V2500 Propulsion System — Engine SERVICE BULLETIN

Subject: Transmittal of Revision 2 to Service Bulletin Number V2500-ENG-73-0137

ENGINE - POWERPLANT - INSTALLATION OF NEW TERMINAL BLOCK ASSEMBLY

Revision 2 September 15, 1999 V2500-ENG-73-0137

INSTALLATION OF TERMINAL BLOCK ASSY FIGURE 2 SHEET 2

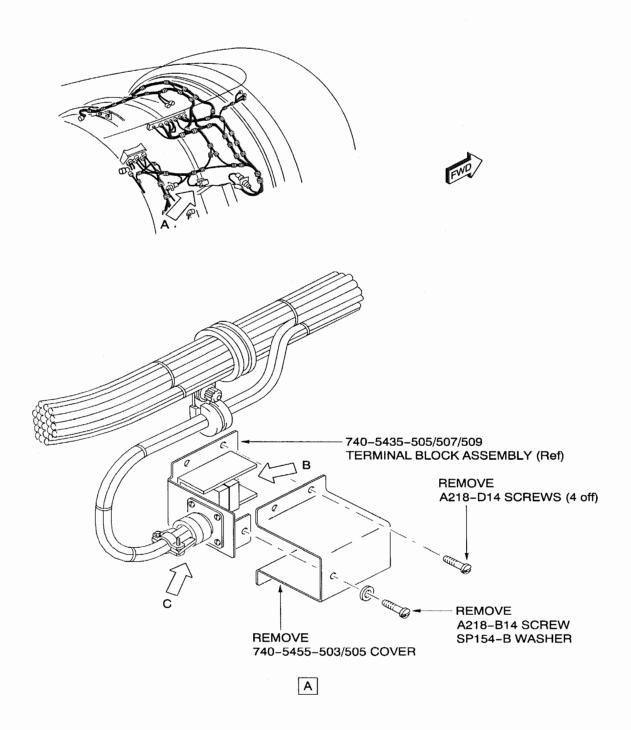
- (29) Remove the tags from the Cables.
- Install the 745-5455-501 Cover to the 745-5435-501 Terminal (30)Block Assembly using the 4 off A218-D14 Screws and A218-B14 Screw and SP154-B Washer. Refer to Figure 2, sheet 2. Torque the five screws to 40 lbfin (4.5 Nm).
- C. Post-requisite Instructions
 - (1) Close the Fan Cowl Doors as instructed in the A320/V2500-A1, A320/A321/V2500-A5 Aircraft Maintenance Manual, Task 71-13-00-410-010.
 - (2) Do a test of the engine electrical system as instructed in the A320/V2500-A1, A320/A321/V2500-A5 Aircraft Maintenance Manual, Task 71-00-00-710-017.
- D. Recording Instructions

REMOVAL OF TERMINAL BLOCK ASSY FIGURE 1 SHEET 1

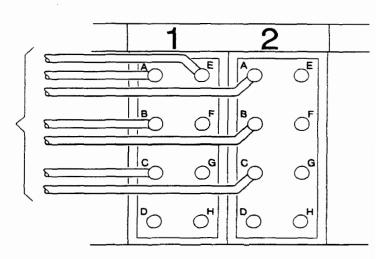
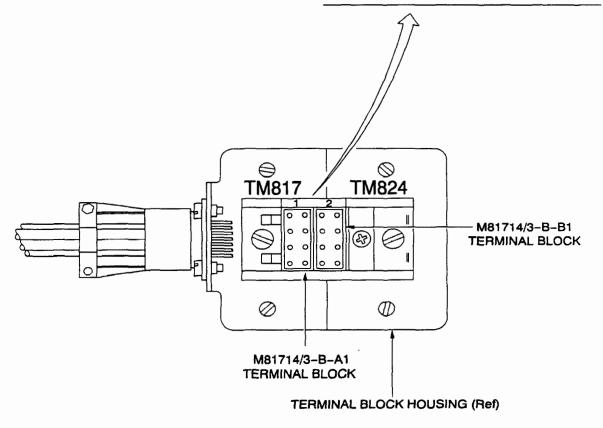
- в. Rework/Modification Instructions
 - (1) Remove 1 off A218-B14 Screw and SP154-B Washer and 4 off A218-D14 Screws to release the 740-5455-505/503 Cover from the 740-5435-509/507/505 Terminal Block Assembly. Remove the cover. Refer to Figure 1, sheet 1.

REMOVAL OF TERMINAL BLOCK ASSY FIGURE 1 SHEET 2

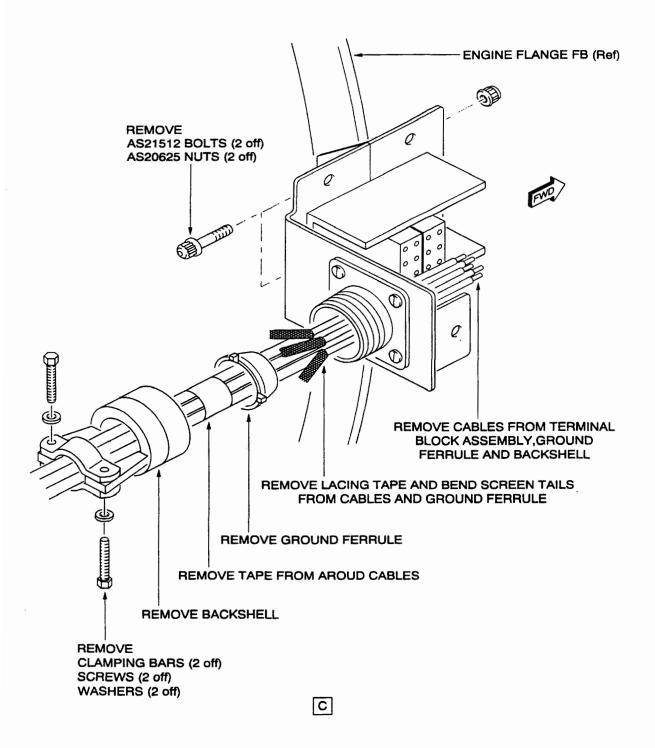
- Attach temporary tags to each Harness Cable to identify to (2) which Terminal Block (M81714/3-B-A1 or M81714/3-B-B1) and to which Terminals (identified A thru H) that the Cables are connected. Refer to Figure 1, sheet 2.

REMOVAL OF TERMINAL BLOCK ASSY FIGURE 1 SHEET 3

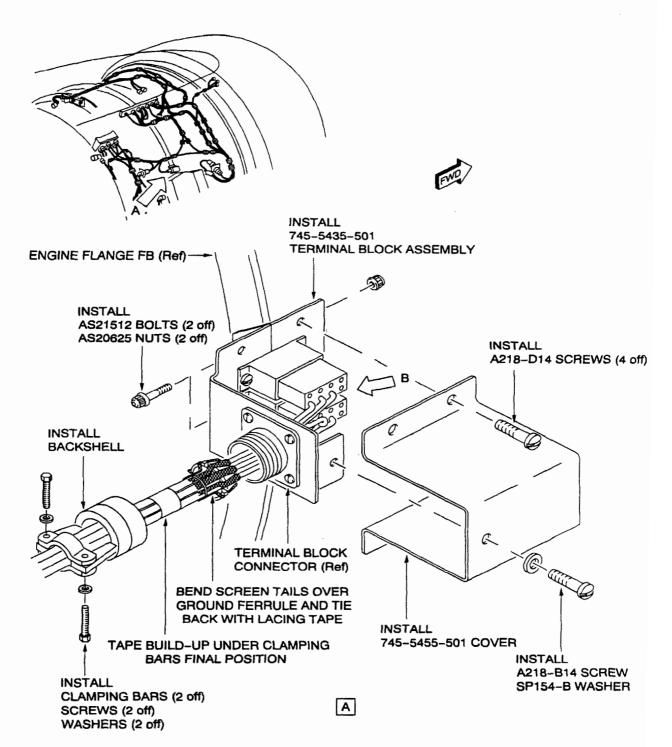
- (3) Use a M81968/14/02 Cable Inserter/Extractor tool to remove the Cables from the Terminal Block.
 - Remove the Screws and Washers to release the Clamping Bars (4) from the Backshell. Remove the Clamping Bars. Refer to Figure 1, sheet 3.

INSTALLATION OF TERMINAL BLOCK ASSY FIGURE 2 SHEET 1

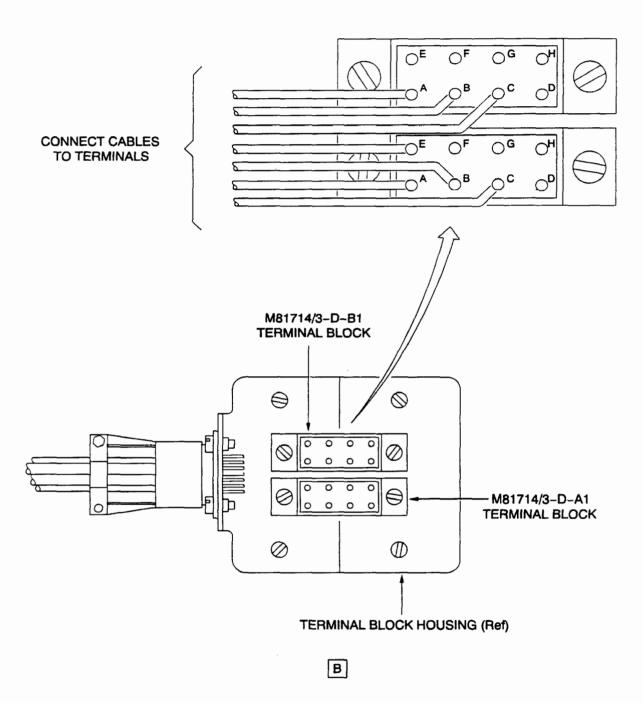
- (11) Remove the 1 off A218-B14 Screw and SP154-B Washer and 4 off A218-D14 Screws to release the 745-5455-501 Cover from the new 745-5435-501 Terminal Block Assembly. Remove the cover. Refer to Figure 2, sheet 1.
